Subject: Effects of Environmental and Electrochemical Factors on the Localized Corrosion of Zircaloy-4, Intermediate Milestone 01402.571.020

Responses to comments and suggestions by NRC on IM 01402.571.020 "Effects of Environmental and Electrochemical Factors on the Localized Corrosion of Zircaloy-4"

Figure 1

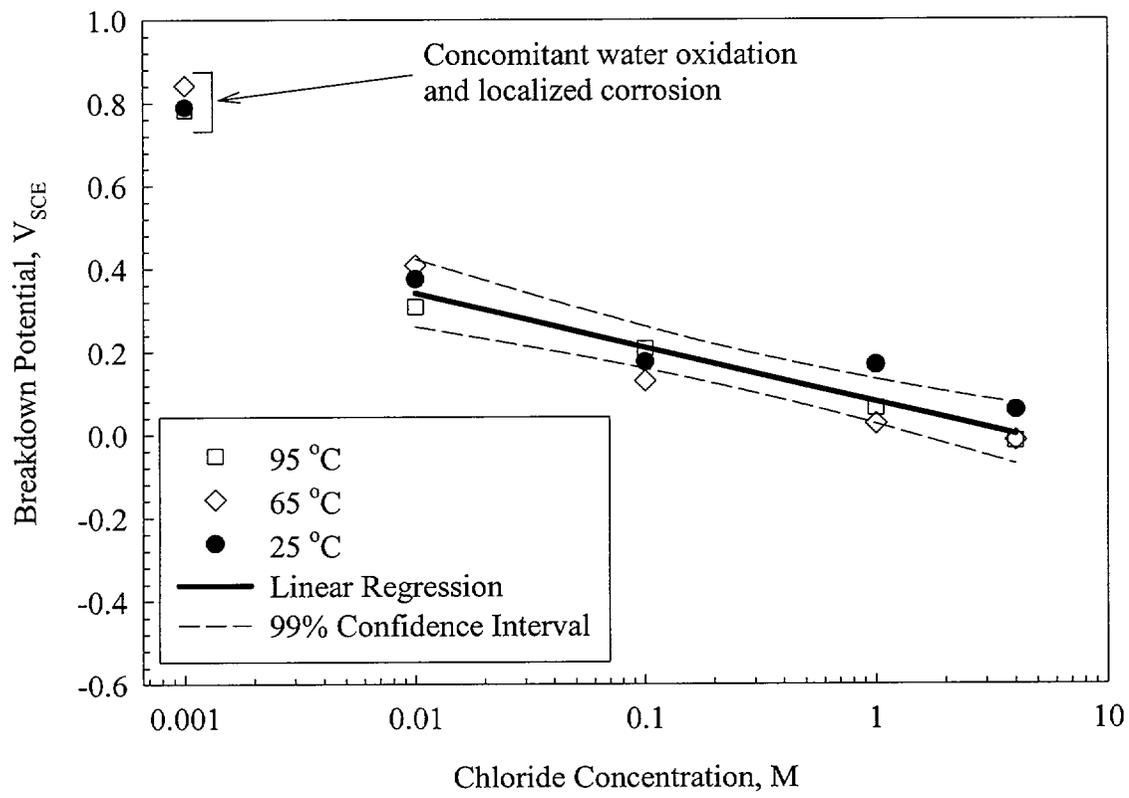
6. Units for figure 1 should be V not mV.

Accept.

Figure 4

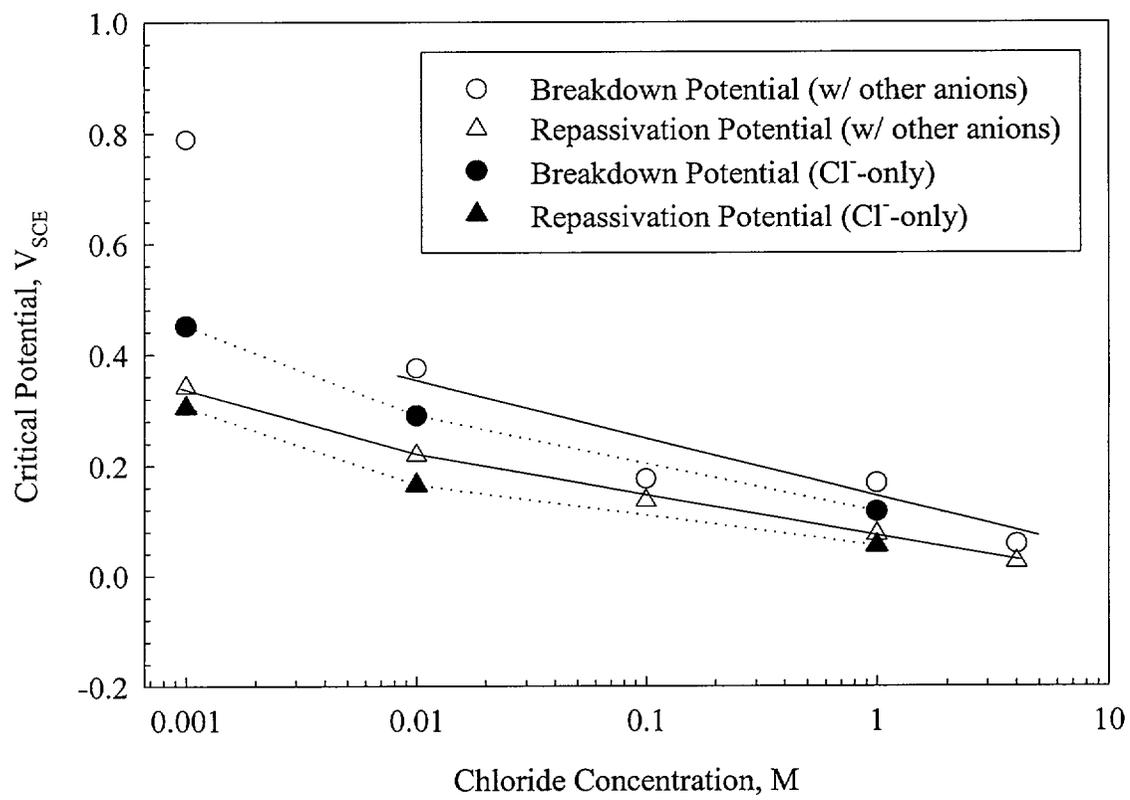
1. The use of the term MGR, as in monitored geologic repository, is not acceptable. Either the authors will need a direct citation for that term, or preferably they should remove all usage of the term. Currently the NRC does not refer to the potential geologic repository as a MGR. MGR is cited on pages 2 (3 times), and page 4 (twice) and in Figure 4 caption.

Accept. See response to Reviewer 1, comment 1.

Figure 7

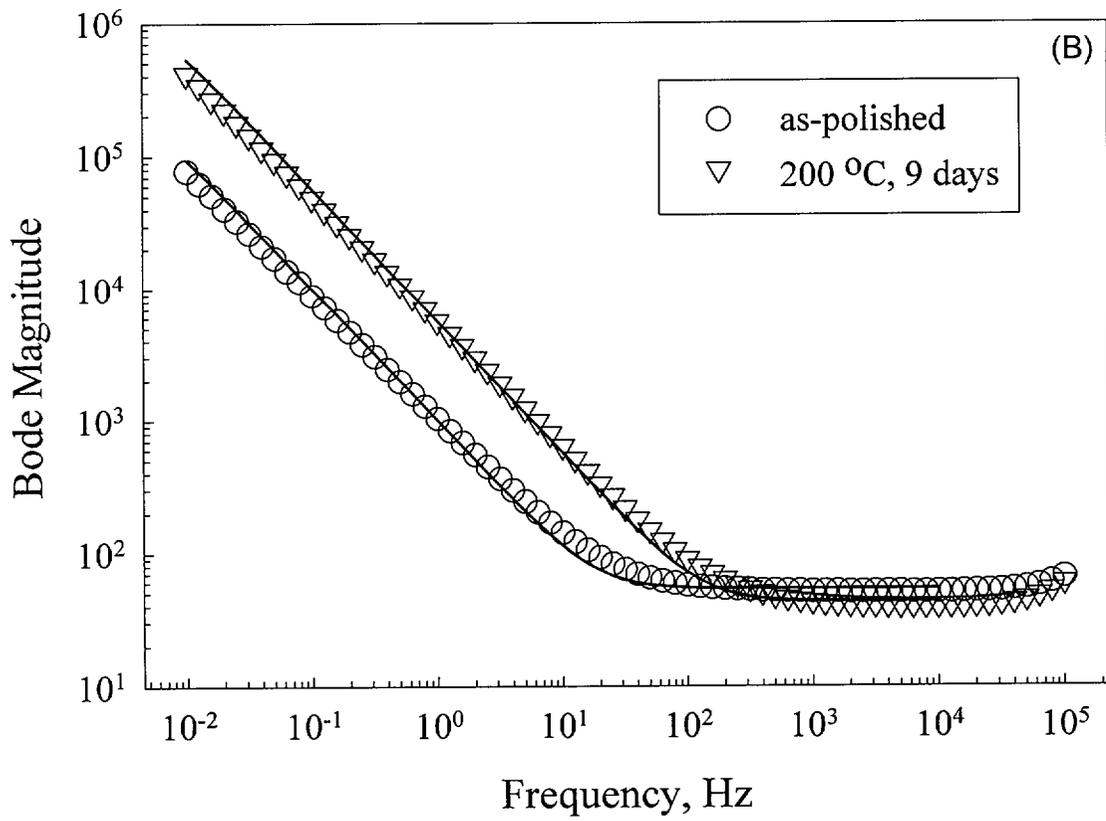
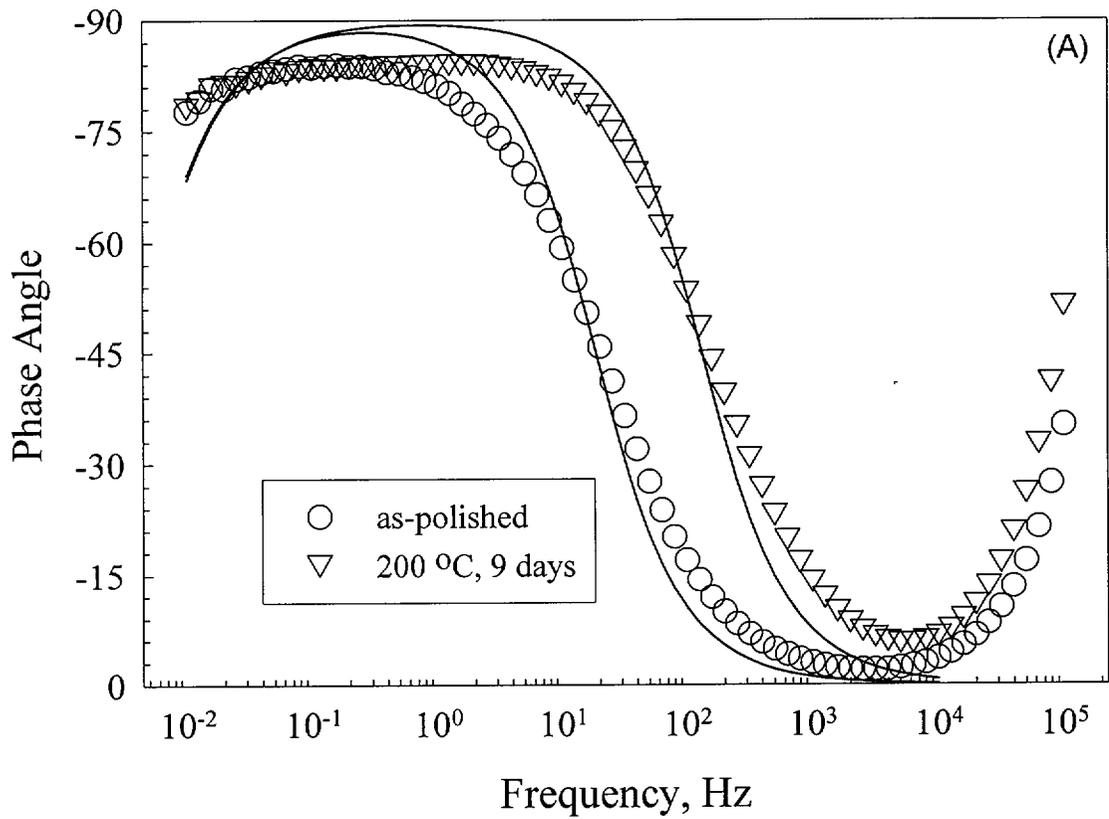
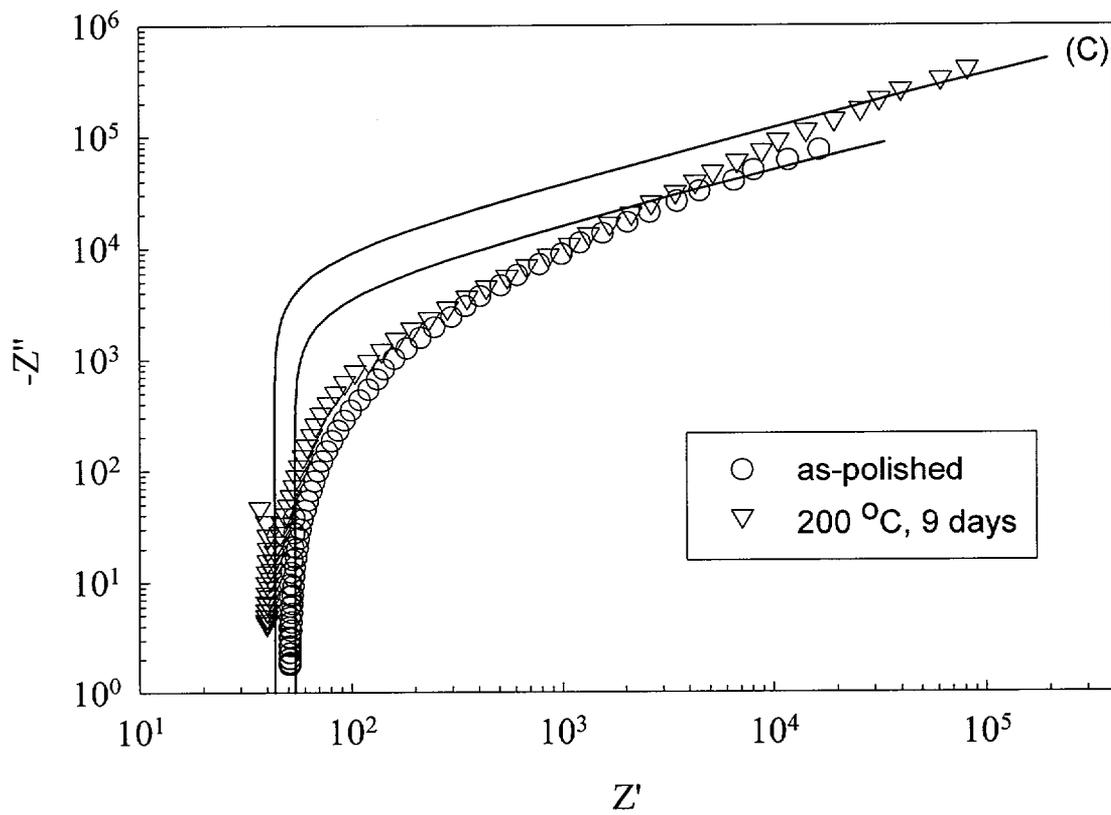
4. I found Figure 7 and its caption to be confusing. I would suggest that the Figure be labeled A, B, and C and the caption broken out to reflect the figure for phase angle (A?), Bode (B?), and magnitude (C?).

Accept. The figure and the caption have been modified.
